Avon Advisory Planning Commission Meeting
January 26, 2026 at 6:30 pm
at Avon Town Hall

DPR 25-12: Park Place Crossing – 56-108 Park Place Boulevard (approx. address)

Planning & Building Department Staff Report

Exhibit C – Planning TAC Letter (Page 1 of 4)

Exhibit B2 – Revised Proposed Site Plan (Received 2-Jan-2026)

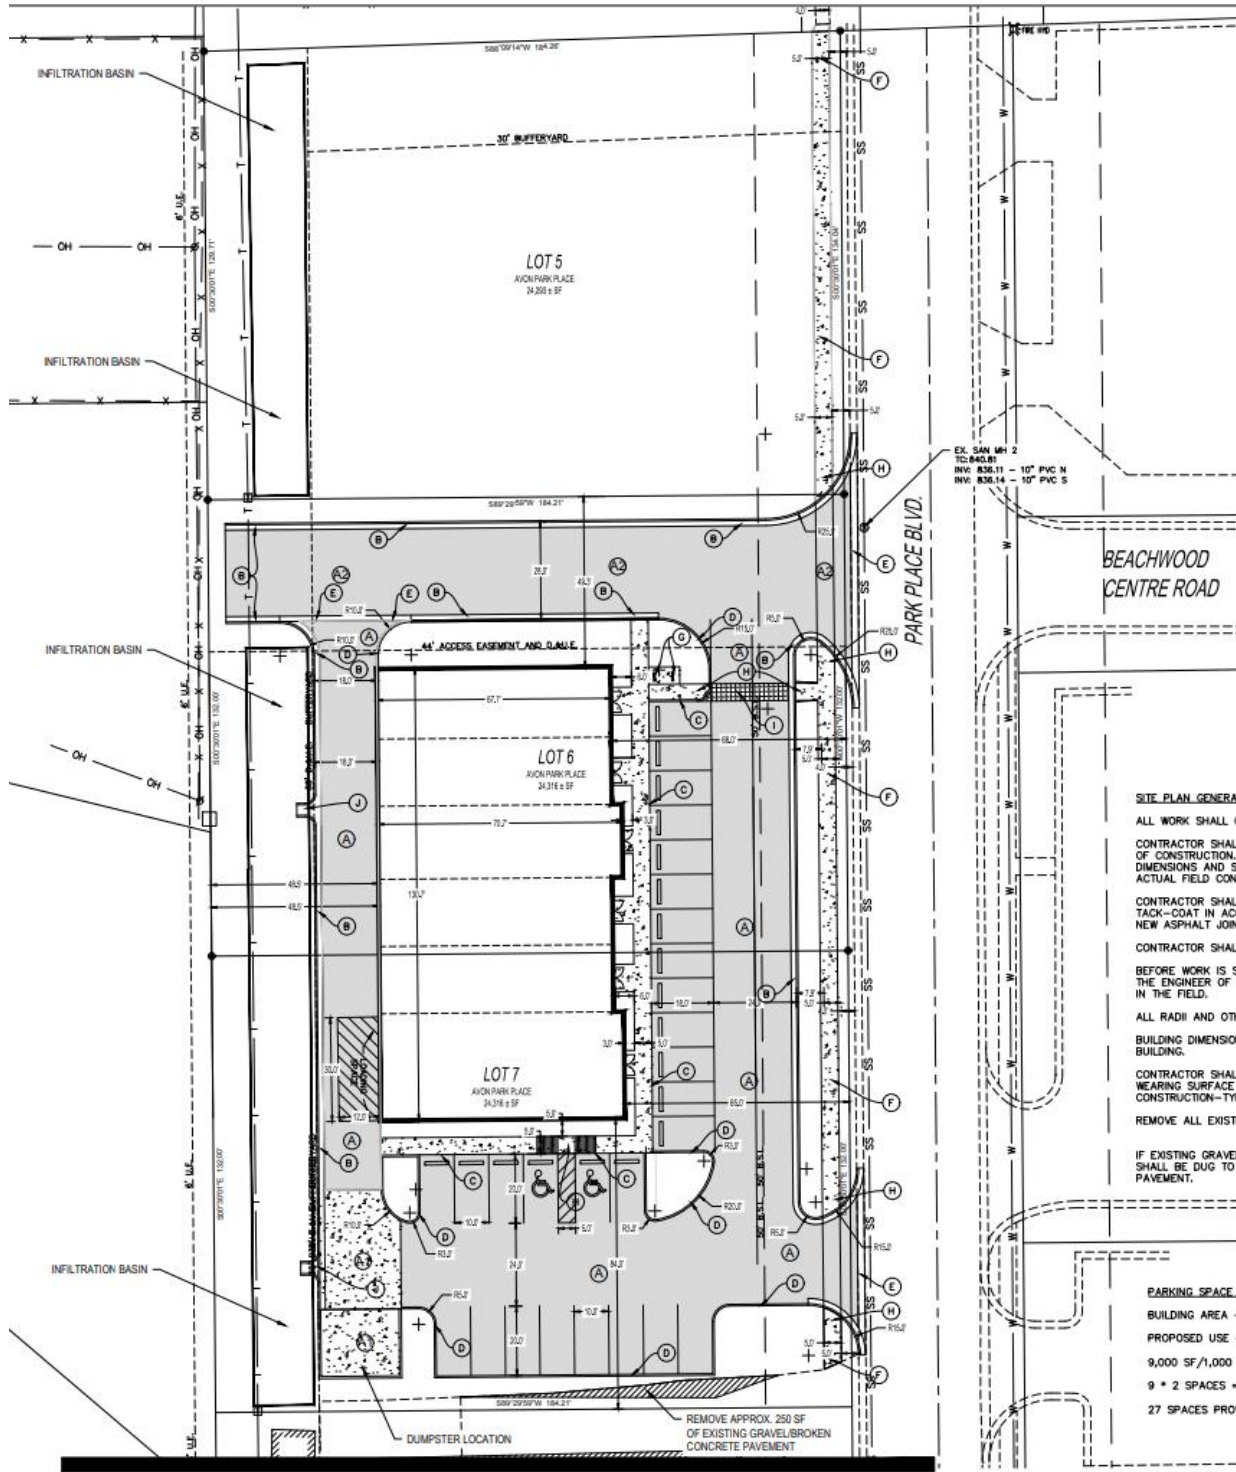
2. Per comments from the Department of Public Works and UDO 2.10(L), an extension of the business collector street (Beechwood Centre Road) identified in the Town of Avon Thoroughfare Plan must be constructed with development of this site. The site plan will need to be revised to relocate the proposed improvements to accommodate said street extension.

4. There appear to be discrepancies between the submitted site plan and building elevations in that the submitted building elevations appear to show six entrances on the east facade, but the site plan shows only four. Please make sure these plans match.

7. Per UDO 2.10(M)(1), a minimum 20' deep front yard landscape buffer is required. The submitted plans are deficient. Please revise plans accordingly or request a variance or waiver (if eligible).

12. Per UDO Table 6.1, 90-degree angle parking requires 20-foot deep spaces, however, 18-foot deep spaces are shown in one of the rows. A variance or waiver can be requested, or the plans will need to be revised accordingly.

13. The application indicates that the building would be used for "office flex space". The closest match to this for purpose of parking requirements in UDO Table 6.3 would be "Office, All Others", which requires 2 spaces per 1,000 square feet of gross floor area, which would require 49 parking spaces for the proposed 24,293 square-foot building. Only 33 spaces are shown on the proposed plan. A variance or waiver can be requested or the plans will need to be revised accordingly, unless the proposed use of the building is revised.

14. Per UDO Table 6.5, one loading space would be required, which would need to be a minimum dimension of 12 feet by 30 feet, unless tractor-trailers would be servicing the site, and would need to meet the standards in UDO 6.13(C). Please revise plans accordingly.

15. Per UDO Table 6.4, a development providing parking spaces within a range of 26 to 50 must provide a minimum of two (2) accessible parking spaces meeting the standards of UDO 6.12(E). No such spaces appear to be indicated on the plans. Please revise the plans accordingly.

18. Per UDO 6.11(D)(3), the first twenty (20) feet of a drive must be kept free from parking maneuvers. The parking space at the southeast corner of the site would violate this requirement. Please revise plans accordingly.

Exhibit C2 – Areas Deficient of Foundation Planting Requirement

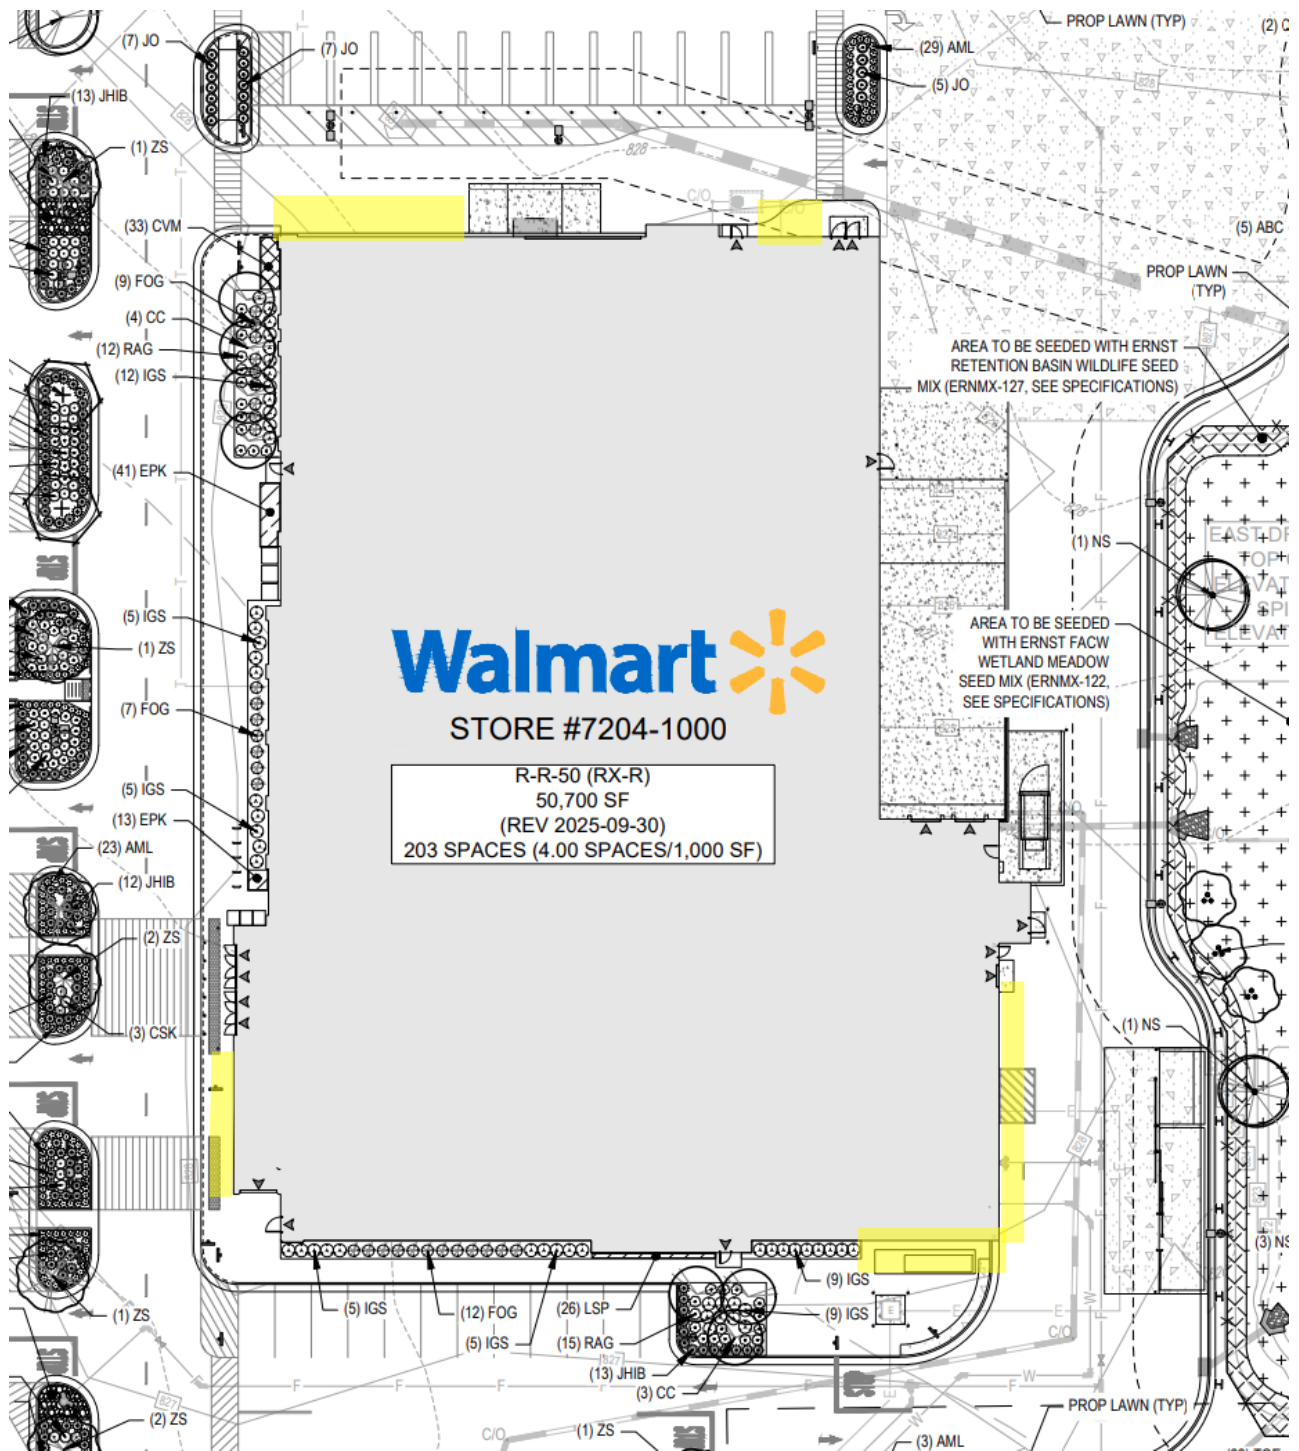
Per UDO 6.5 (A), a minimum five-foot planting area must be provided around the perimeter of the building, excluding access to the buildings, such as loading areas and doorways. The landscape plan submitted subsequent to TAC review has increased the proposed foundation planting areas, but is still deficient along several portions of the building (see Exhibits C1 & C2).

Per UDO 6.7(B)(4), each parking lot landscape island must have a minimum of one tree. The revised landscape plan is still deficient of this standard.

A further revised landscape plan should be submitted to demonstrate compliance with the foundation planting and interior parking lot landscaping requirements.

Exhibit E – Aerial Photo w/ Measurements of Proposed Driveway Separation

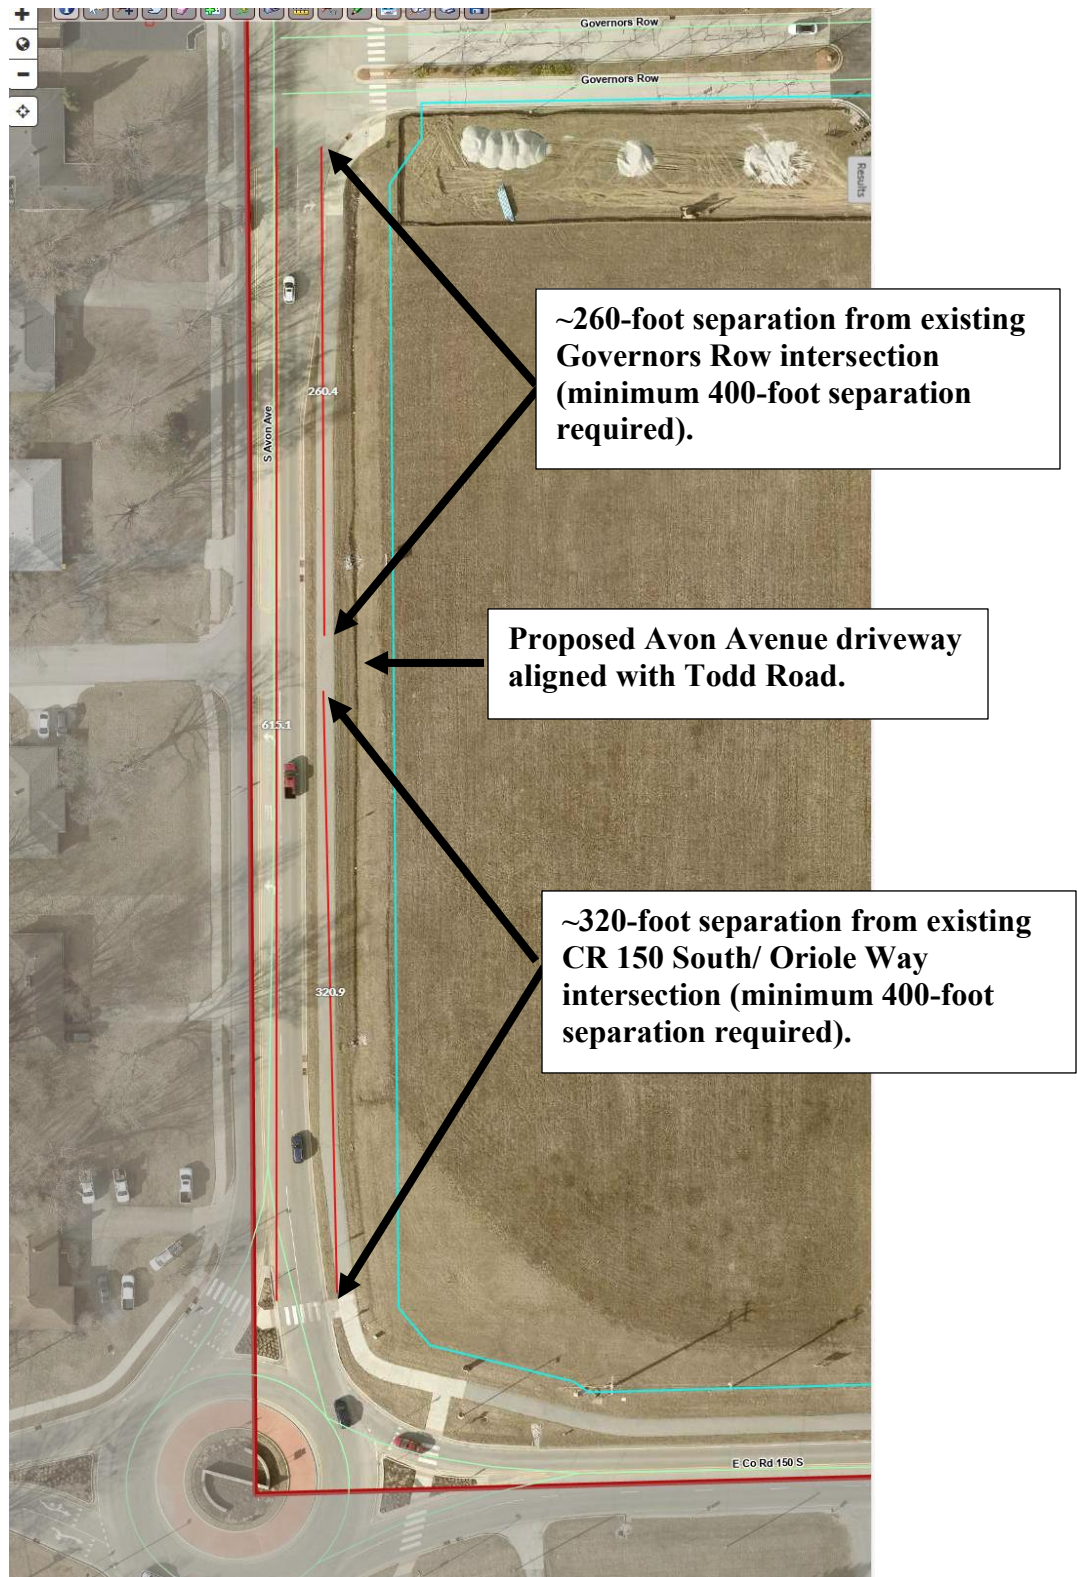
After evaluating the proposed development plan, the petitioner's TIS, and comments from the Town's consulting traffic engineer and Public Works Director, the Town opposes the requested waiver for direct access to Avon Avenue (see Exhibits E & G), and the Town has determined that the property owner should construct the following necessary improvements concurrently with development of the site.

Petitioner's response: "the ordinance requires 400 feet of separation, however a 35% reduction of the 400 feet, to 260 feet, is permitted via a waiver. The proposed plan provides a separation distance between intersections over 260 feet."

Petitioner's response: "the subject property's size and shape limit the ability to achieve the 400-foot separation without creating significant design challenges such as encroaching into the adjacent roundabout intersection."

While the property's frontage is not lengthy enough to meet the separation standards for a new direct access point to Avon Avenue, the site is already served by driveways onto County Road 150 South/ Oriole Way and onto Governors Row, both of which provide full access to/from Avon Avenue.

Exhibit D – Building Elevations Building A

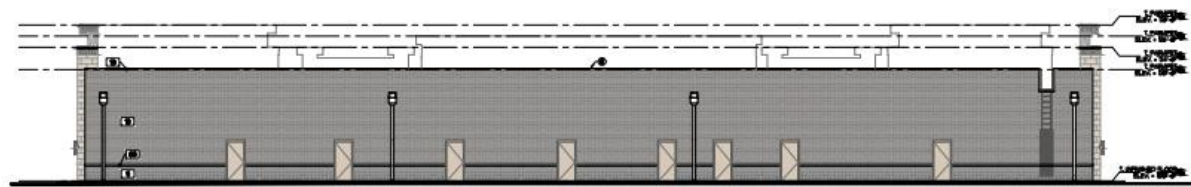
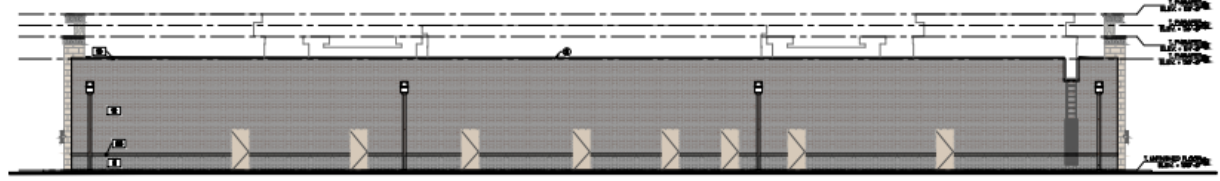
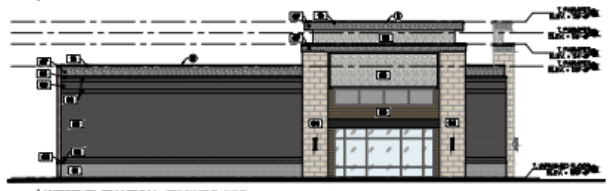
Waiver of Design Standards of UDO 2.10(O)(2)(a) to provide for reduced masonry (80% masonry required)

The proposed percentage of brick ranges from 36% on the front façade to 97% on the rear façade. Therefore, the overall appearance of the buildings will meet the intent of the UDO for having high-quality materials. While the front façade does not meet the 80% requirement, the change of materials offers a superior visual interest to warrant a deviation from the brick standard.

Petitioner's response: "this design improves upon the aesthetics of the surrounding area and uses high quality finishes, including: brick, cast stone, Nichiha panels and EIFS accents."

Petitioner's response: "it is keeping/improving upon the character of the area, and abides by the UDO's design quality intent, while also providing signage area above each tenant to allow ease of modification and maintenance through material selection, creating a better-looking façade over time."

Petitioner's response: "it consists of high-quality finishes and offers a new and unique design to the area."

Exhibit D – Proposed Landscape Plan

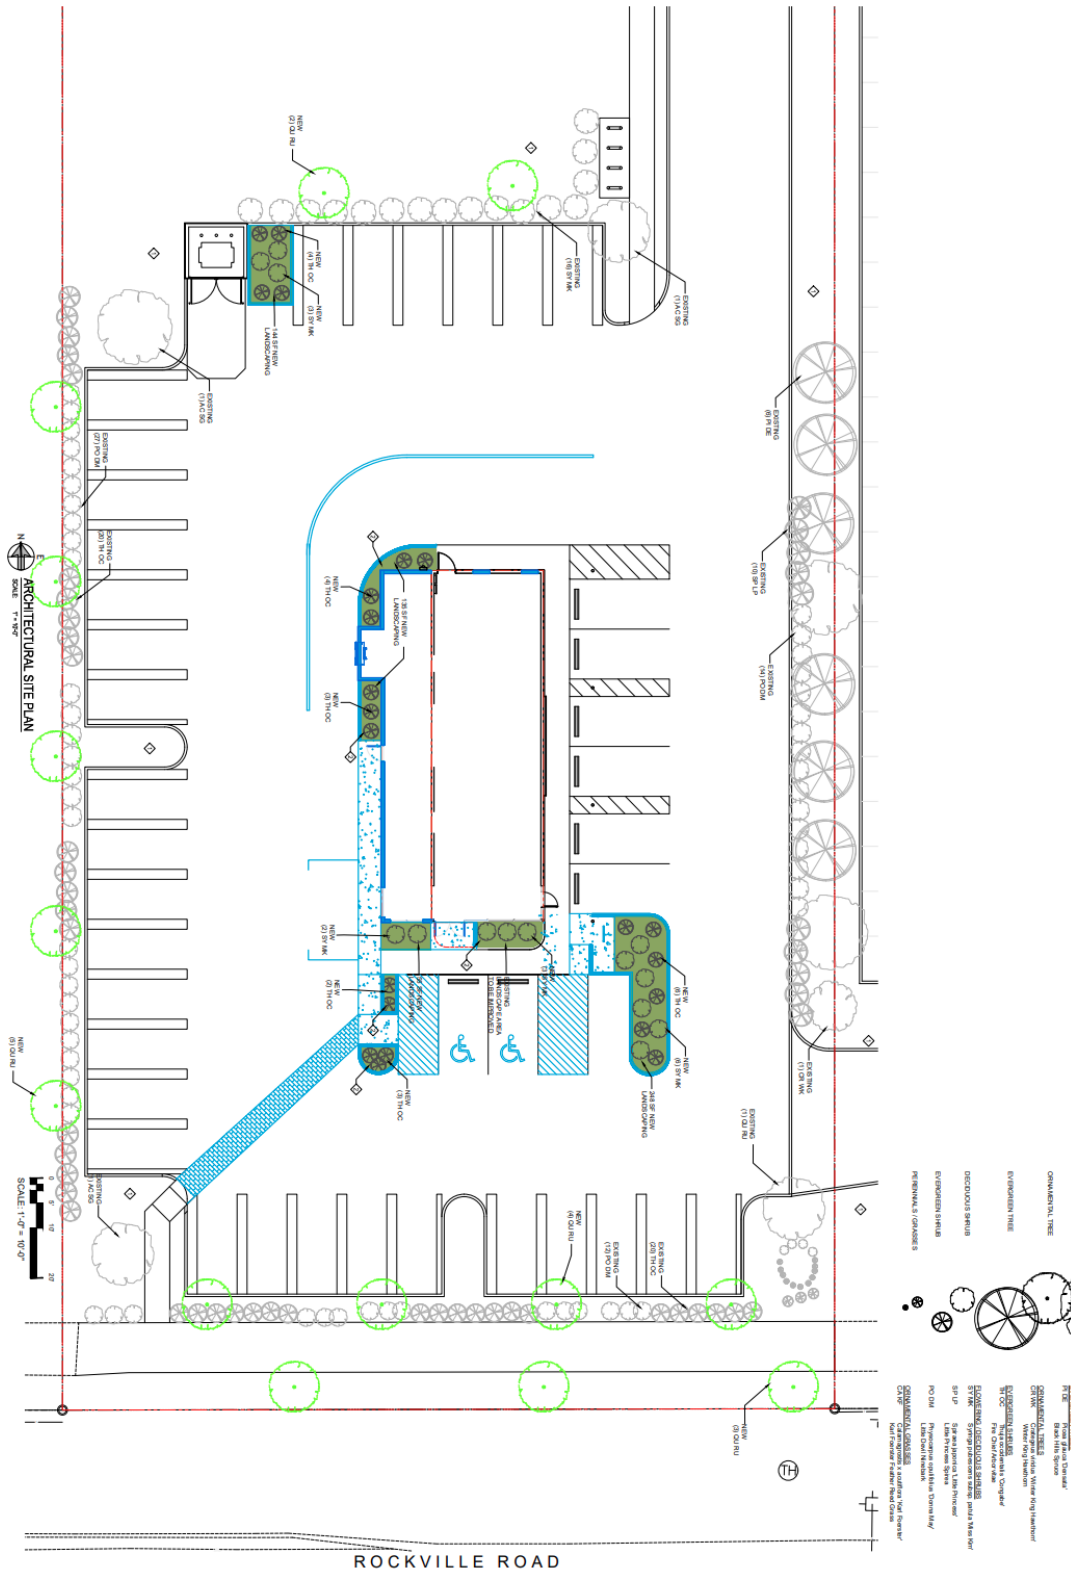
The revised landscape plan, submitted subsequent to the Technical Advisory Committee (TAC) meeting, addresses staff comments requesting additional tree plantings along the site's U.S. Highway 36 frontage and the west perimeter of the parking lot, terminal islands on each end of the parking row adjacent to the south façade, and additional foundation planting areas. It appears that additional landscaping should be included north of the trash enclosure to screen it from Harvest Landing Drive as required by UDO 5.1(H)(1).

Exhibit E – Existing & Proposed Building Elevations (South & North)

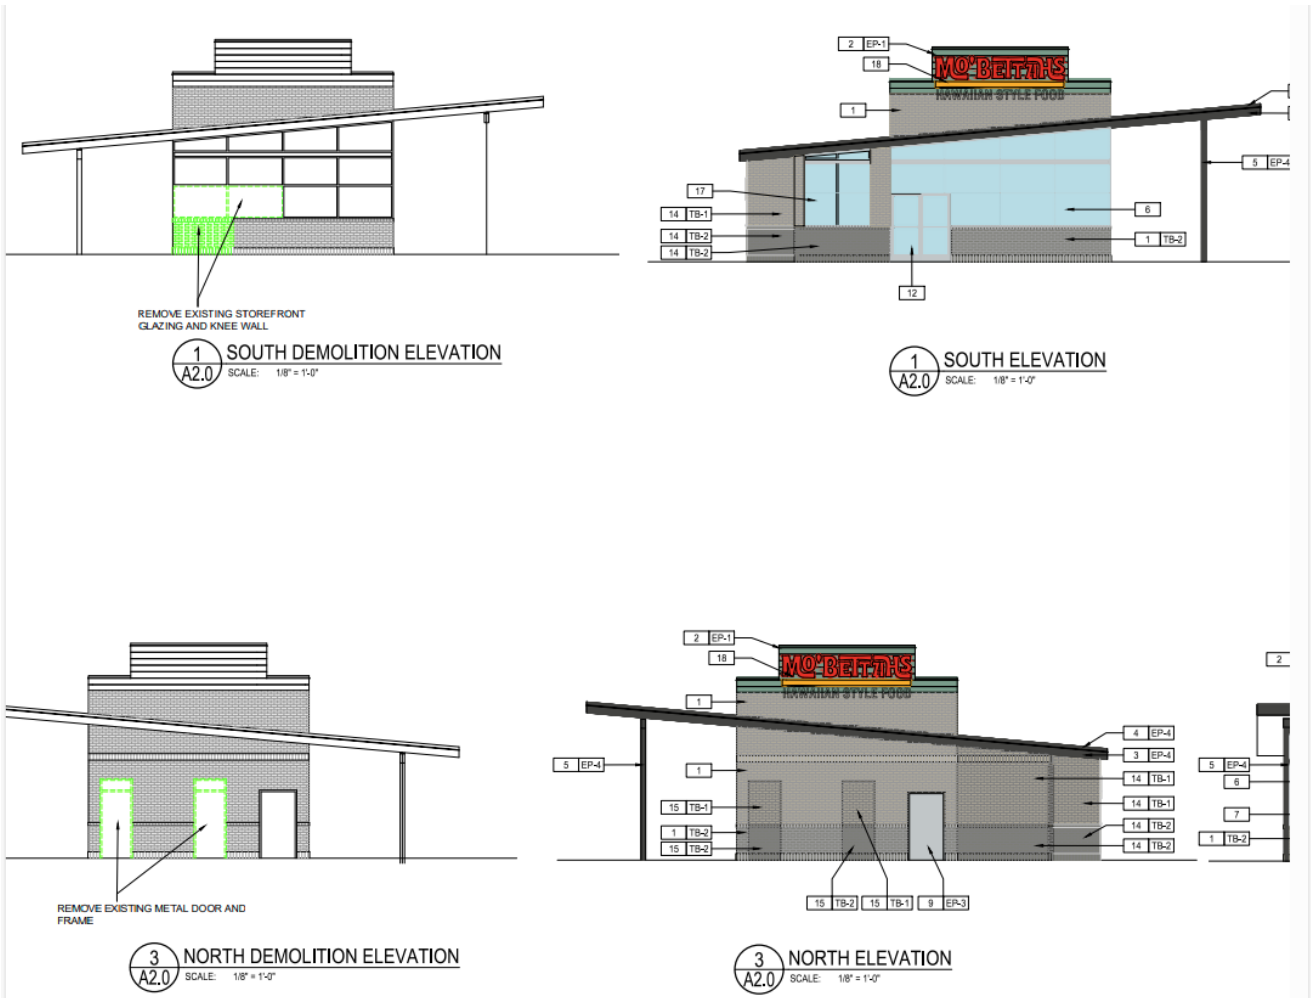
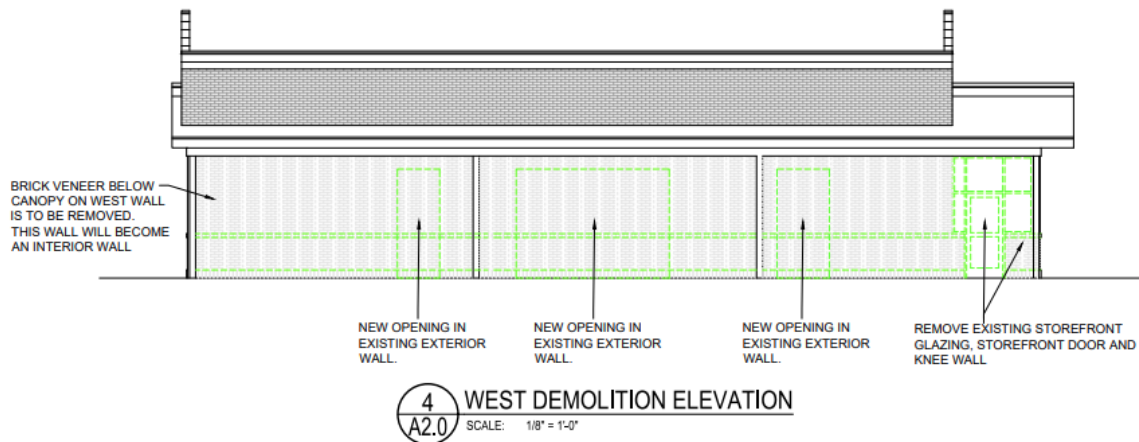
The revised building elevations submitted subsequent to TAC review appear to meet both the general architectural standards of UDO 7.10 as well as the additional U.S. Highway 36 overlay requirements found in UDO 2.10(O), except for the waiver for use of "thin brick", which is addressed below.

Petitioner’s response: “the proposed thin brick will match the existing thin brick.”

Petitioner’s response: “we are asking for this waiver so the addition with thin brick exterior will match existing building exterior, since it will be the most aesthetically pleasing to not have mismatched building exterior materials on the same building.”

Staff agrees that matching the existing exterior material is reasonable and preferable to using a permitted material that might not blend well aesthetically, and that it would be unreasonable to expect the petitioner to replace the existing siding material that is only a few years old.
